BN/5/18/PL

PLAN-022096

Proposal: Resurfacing of existing car park.

Site: Barnham Community Hall, Yapton Road, Barnham, PO22 0AY.

Southern Water MapGuide Browser

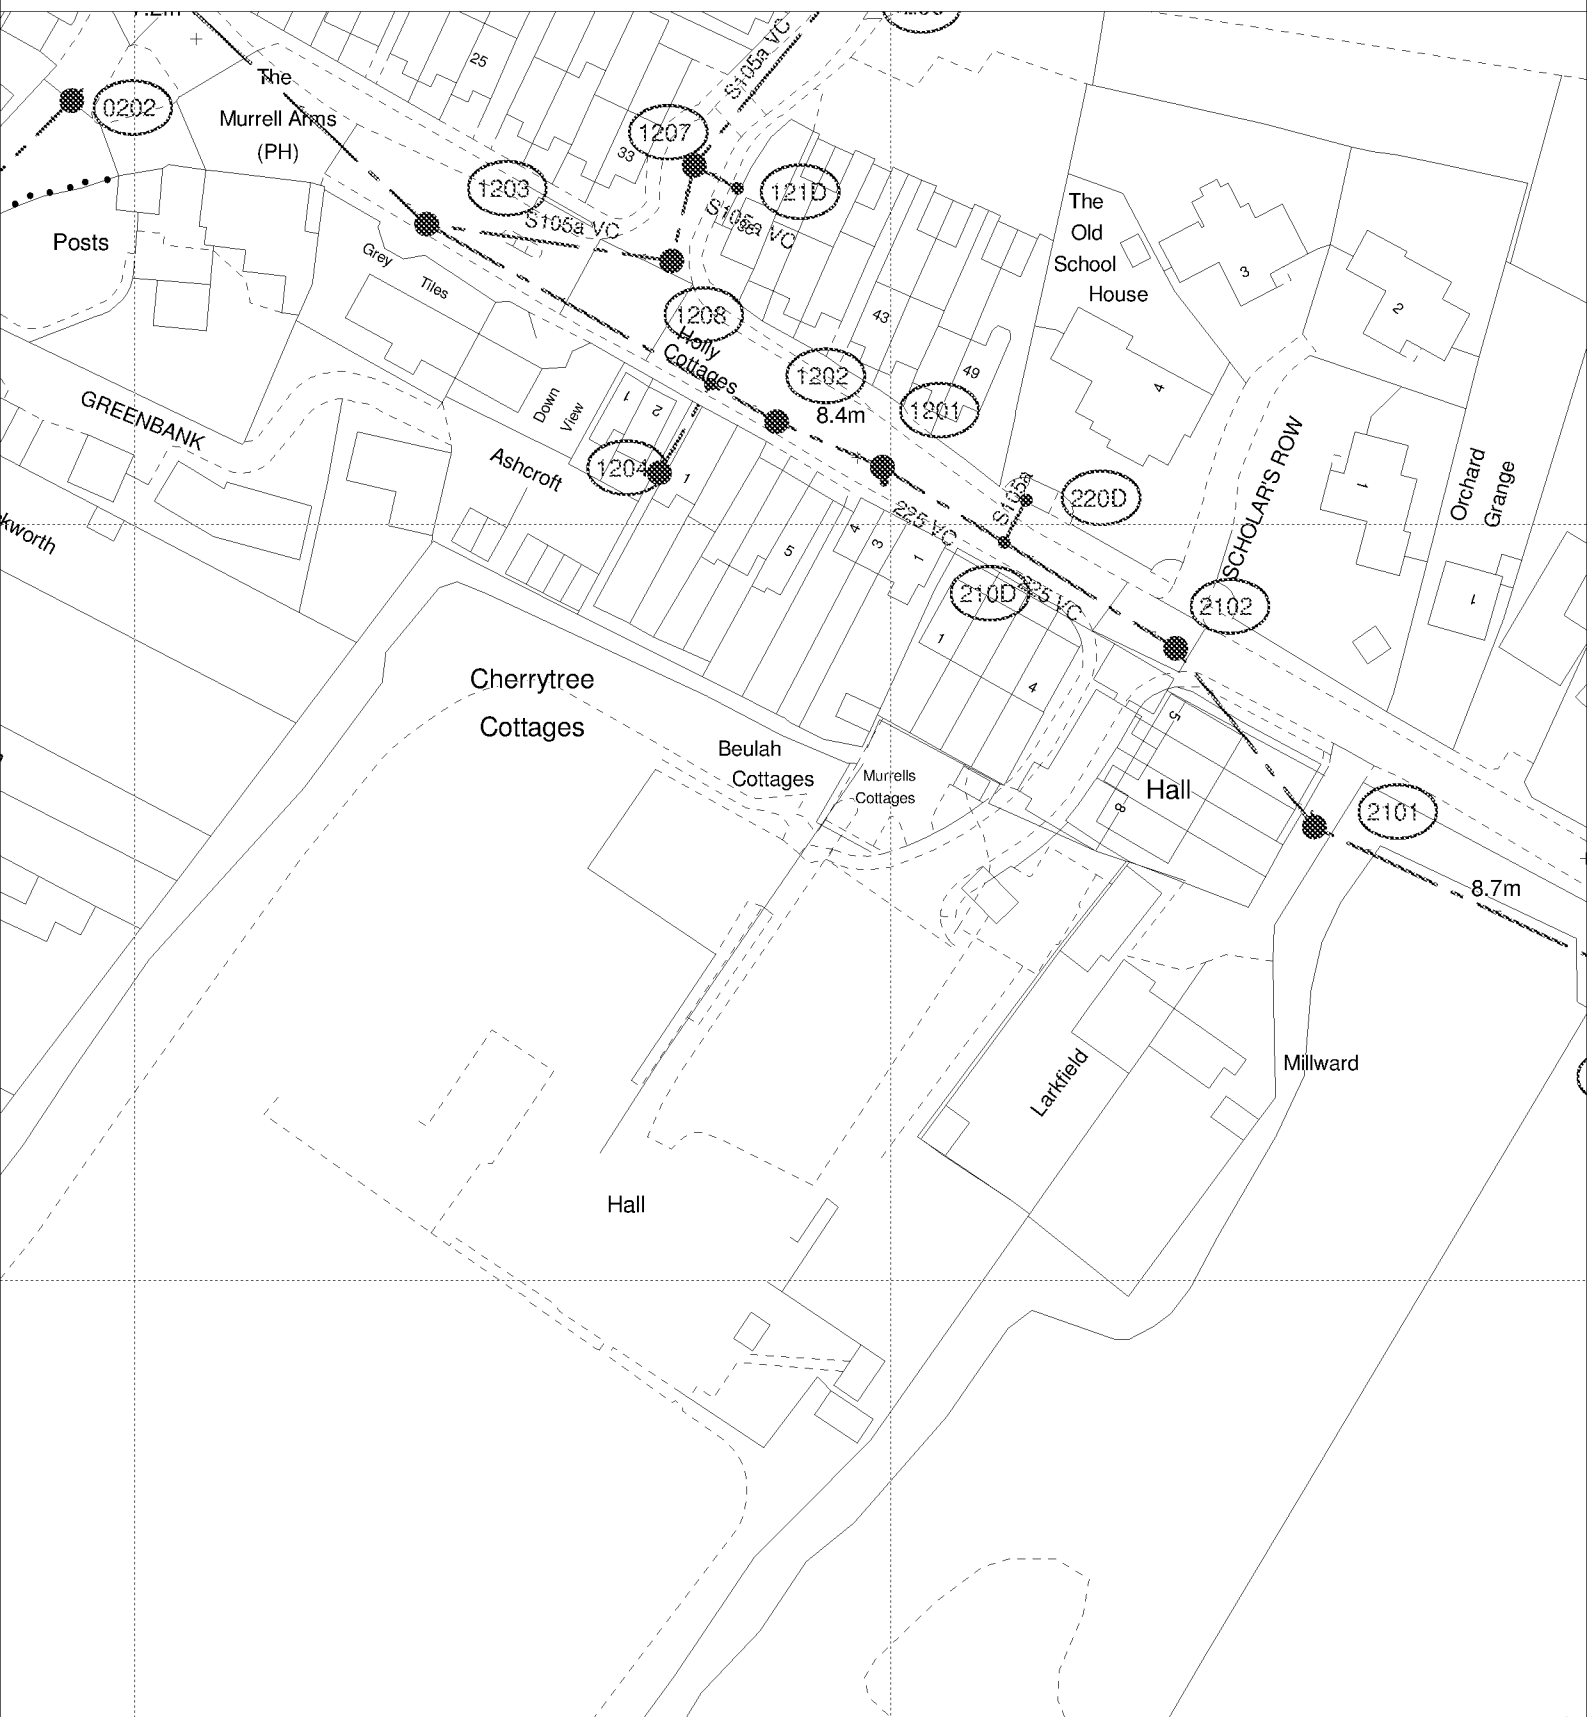
Due to changes in legislation that came in to force on 1st October 2011 regarding the future ownership of sewers it is possible that a sewer now deemed to be public could be crossing the above property. Therefore, should any sewer be found during construction works, an investigation of the sewer will be required to ascertain its condition, the number of properties served, and potential means of access before any further works commence on site.

The applicant is advised to discuss the matter further with Southern Water, Sparrowgrove House, Sparrowgrove, Otterbourne, Hampshire SO21 2SW (Tel: 0330 303 0119) or www.southernwater.co.uk".
